**WARREN WILSON COLLEGE STREAM MITIGATION SITE**

NCDMS Project ID No. 100019  
Full Delivery Contract No. 7188  
USACE Action ID No. SAW-2017-01557  
NCDWR No. 20171158  
RFP No. 16-006991 (Issued: 9/16/16)

### Response to Monitoring Year 3 (2022) DMS Comments

Warren Wilson College Stream Restoration Site  
French Broad River Basin – CU# 06010105– Buncombe County  
DMS Project ID No. 100019  
Contract # 7188

# 2A

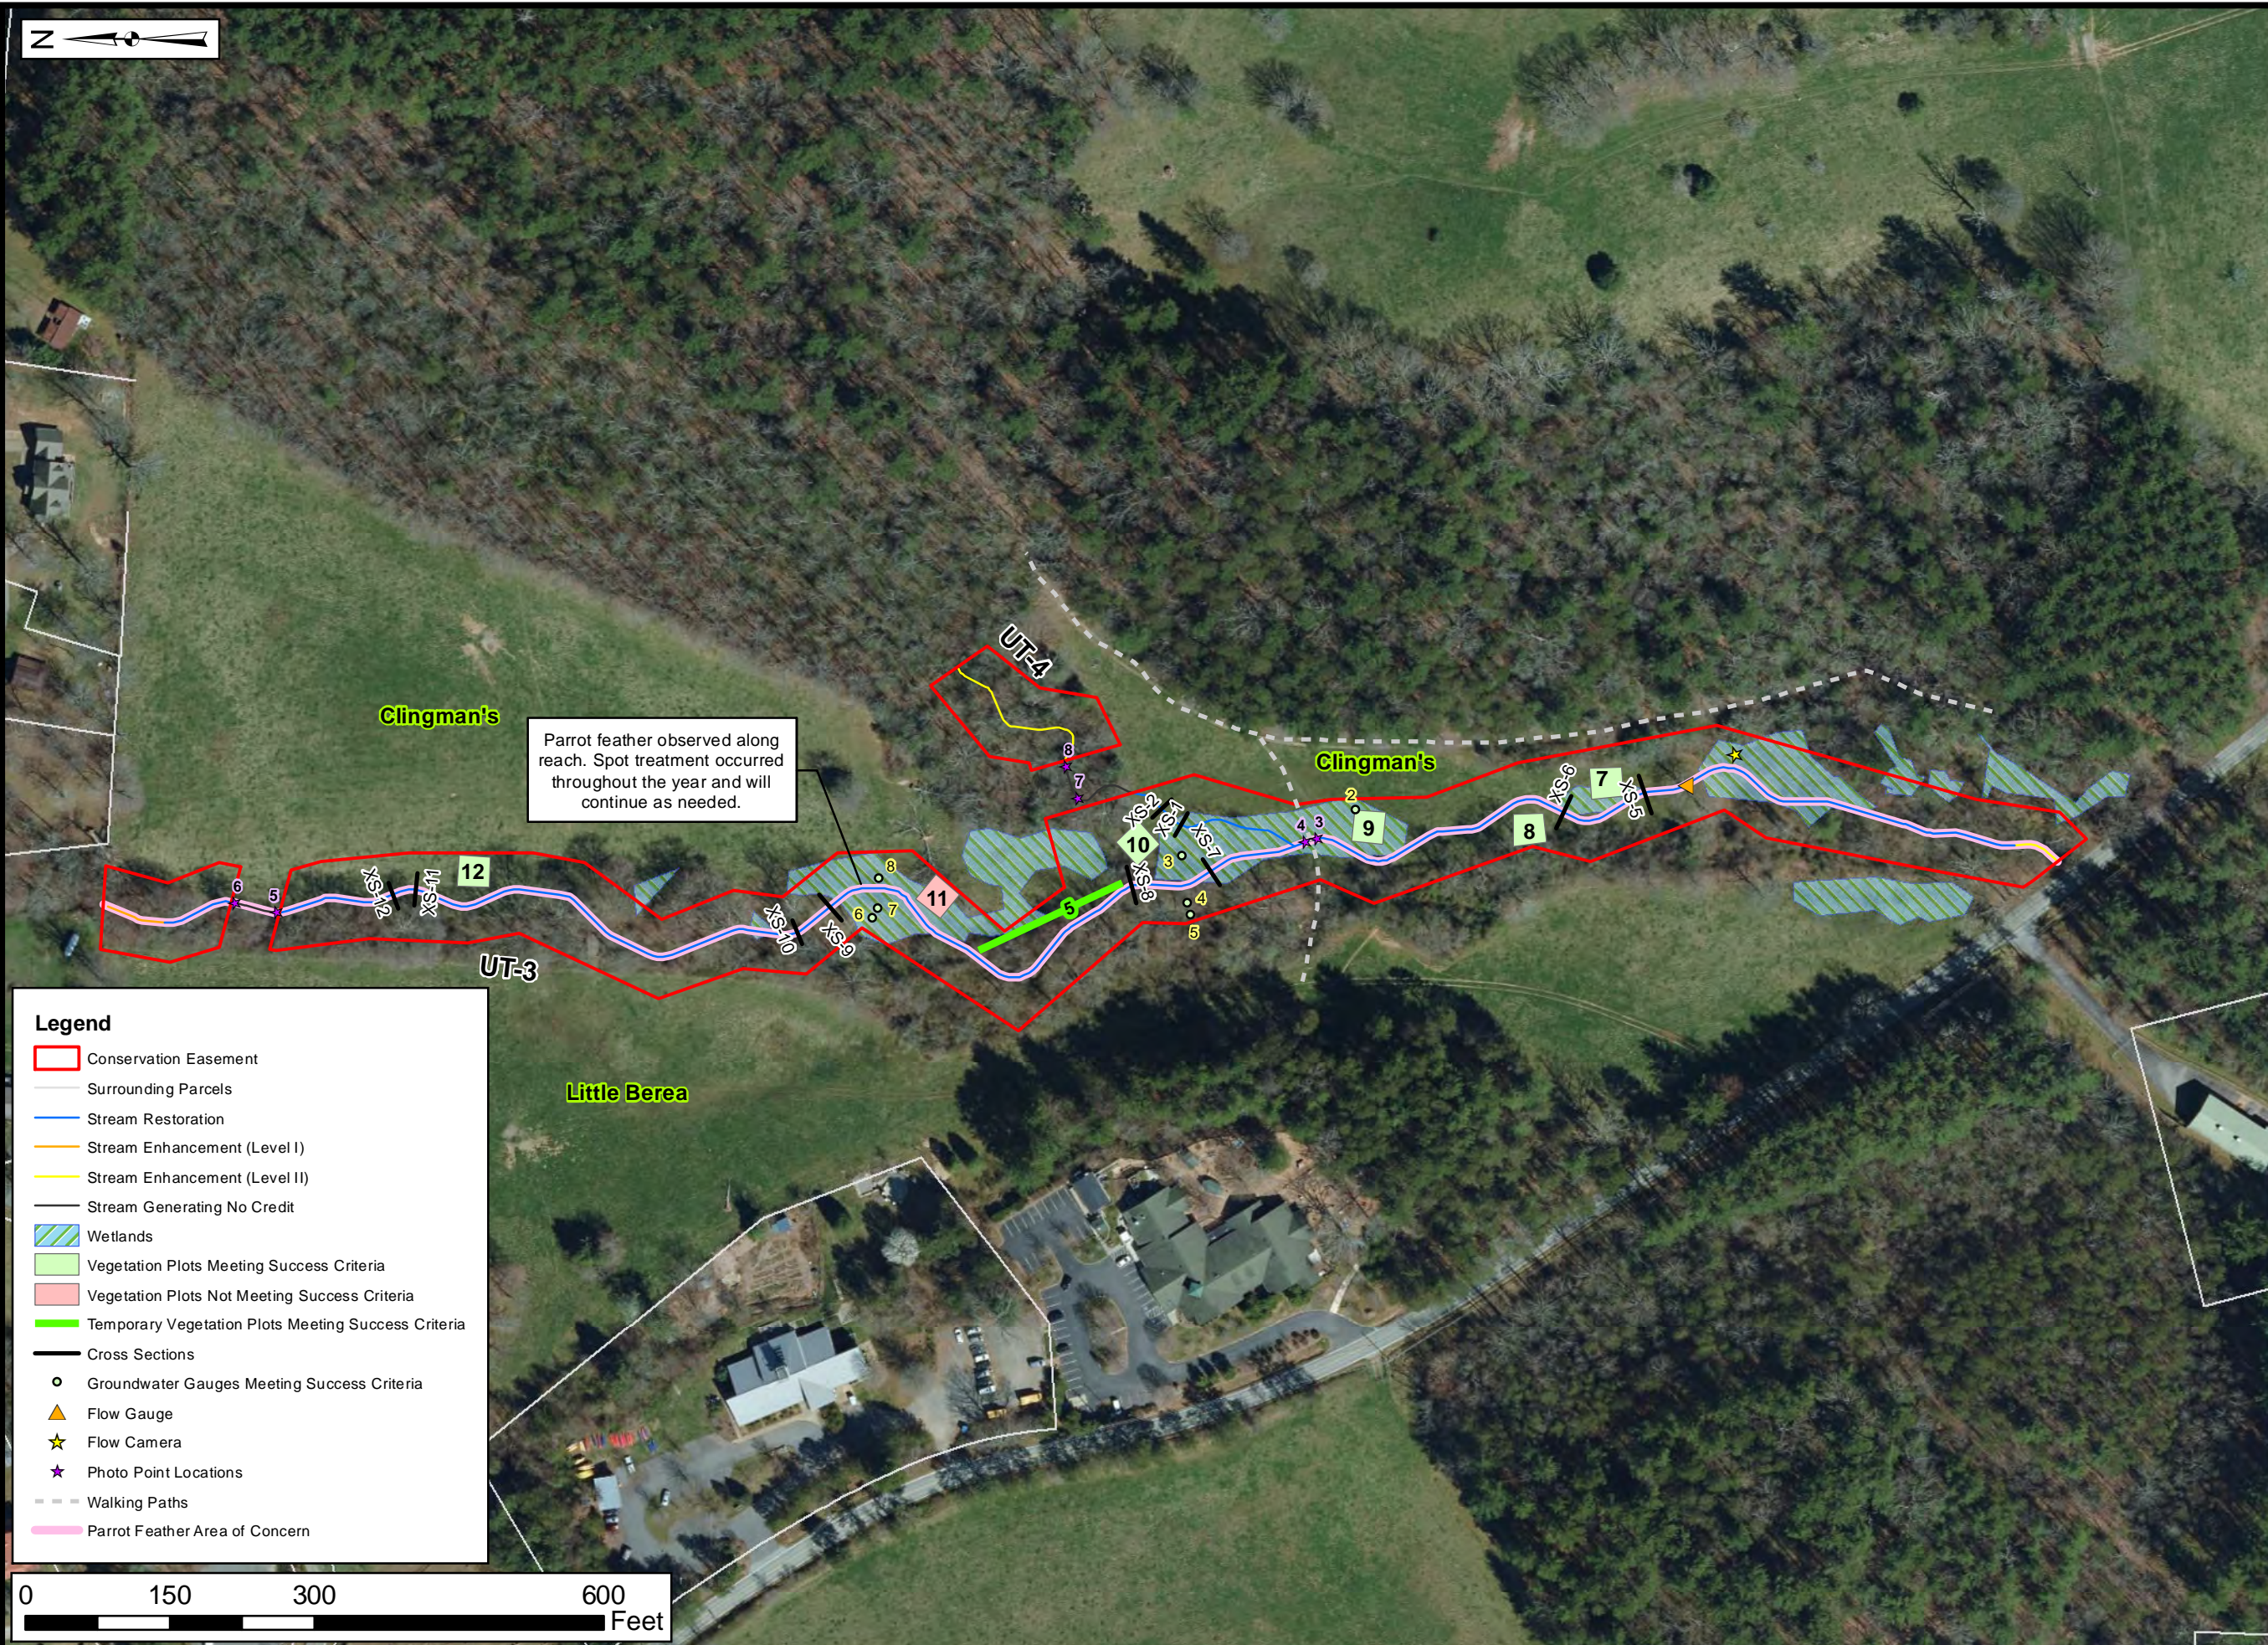
*Invasives on the site were discussed. The IRT asked about the Parrot Feather reported on the site. The Parrot Feather was located on UT3 near VP 8 and will be treated through project closeout. Erin Davis (DWR) recommended that Parrot Feather be called out in the CCPV maps in future monitoring reports.*

7. Section 2.1 Monitoring: In the report text, please discuss any project maintenance activities (invasive treatment, supplemental planting, beaver removal, etc.) that took place in MY3 (2022). As an example, CCPV Sheet 21 indicates; Parrot feather observed along reach. Spot treatment occurred throughout the year and will continue as needed. This and additional invasive treatment and maintenance activities should be discussed in the report text.

*Response: Parrot feather and other areas of invasives species concern are depicted on this year's CCPV.*

[Response: A discussion of the 2022 invasive treatments was added to the “Vegetation Summary” in Section 2.1. These were the only site maintenance activities that took place during MY3 \(2022\).](#)
